Village of Bayside
9075 N. Regent Rd.
Architectural Review Committee Meeting
April 9, 2018
Village Hall Board Room, 6:00 pm

**ARCHITECTURAL REVIEW COMMITTEE
AGENDA**

VILLAGE CODE REVIEW

Proposed Fence Layout
5' solid fence, 1' lattice at top

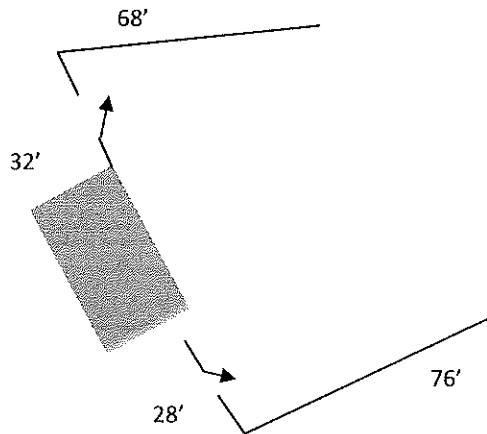
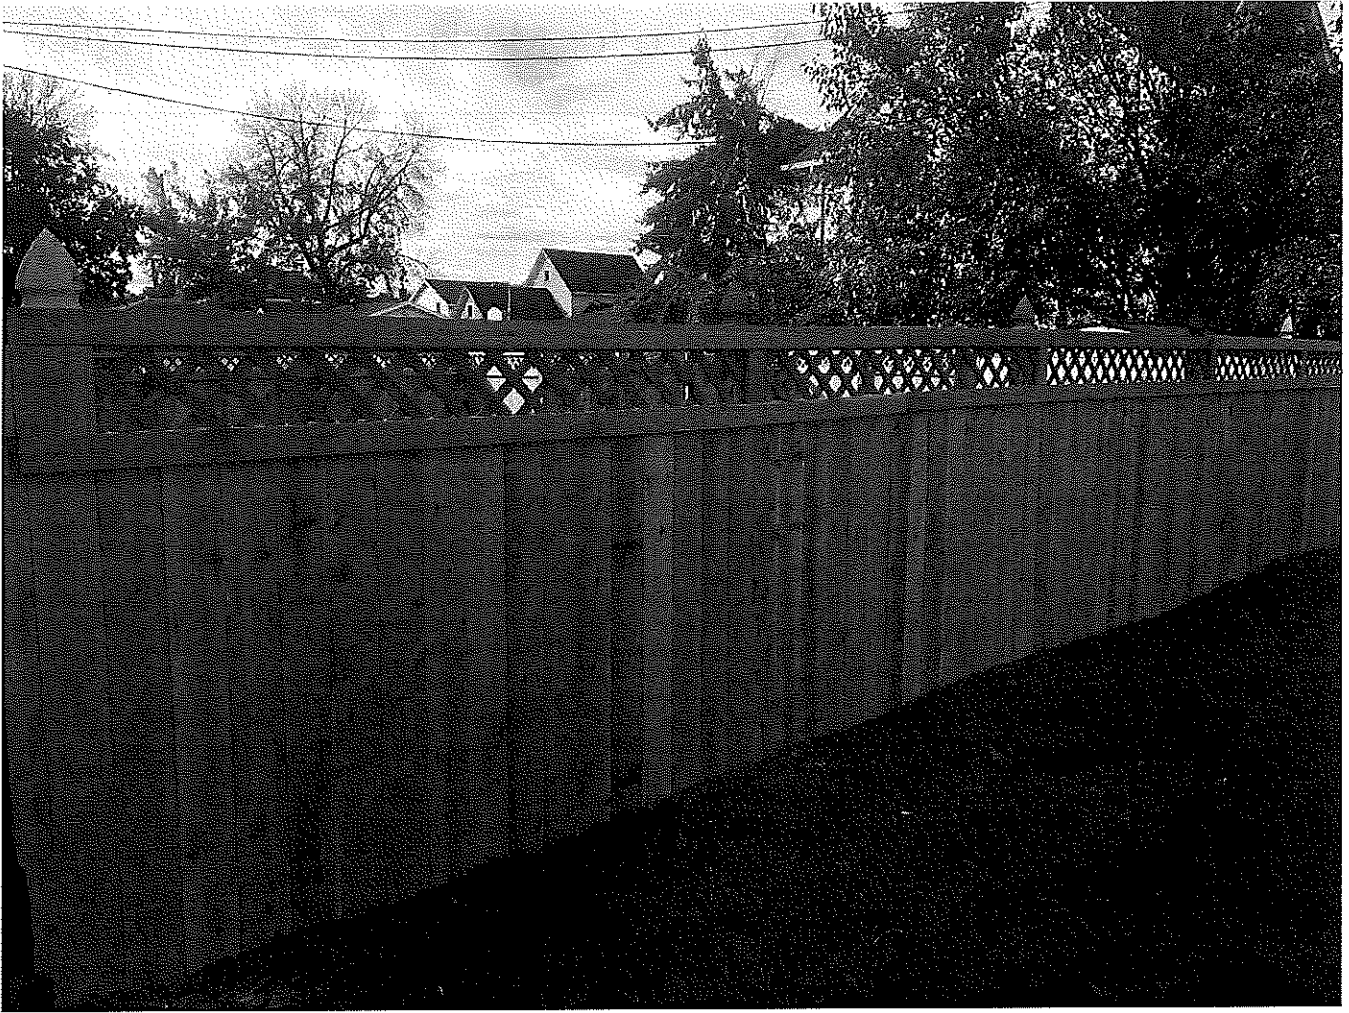
This review of the proposed fence type is based on the following assumptions regarding the submitted photograph:

6ft tall total height
 5ft tall privacy fence (0% open design)
 1ft tall lattice at top (assumed to be 75% open design)

(1ft x 75% open) / 6 total ft in height = 12.5% open

PROPOSED FENCE TYPE DOES NOT COMPLY WITH 25% OPEN DESIGN

OPTIONS TO ACHIEVE COMPLIANCE WITH THIS FENCE STYLE

Option 1: Lattice section would need to be 2 ft tall in order to comply:
 (2 x 75%) / 6 = 25% open design

Option 2: Provide 1" gaps between vertical boards in bottom section of fence:
 (1ft tall lattice x 75%) / 6 = 12.5% open at lattice section
 (1in gap) / (5.5in board + 1in gap) = 15% open at lower section
 27.5% open total

2 FENCE ELEVATION

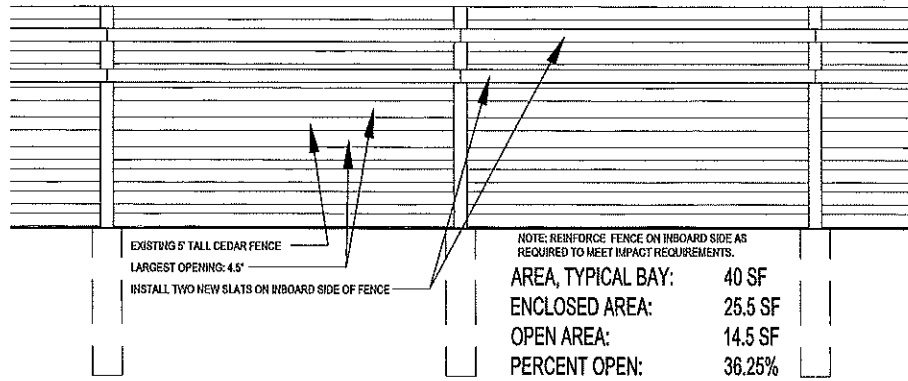
The application notes that the proposed alteration to the existing fence would reduce the open percentage to 36.25% open. As such, the proposed alteration does not comply with village code.

PROPOSED FENCE TYPE DOES NOT COMPLY WITH 50% OPEN DESIGN
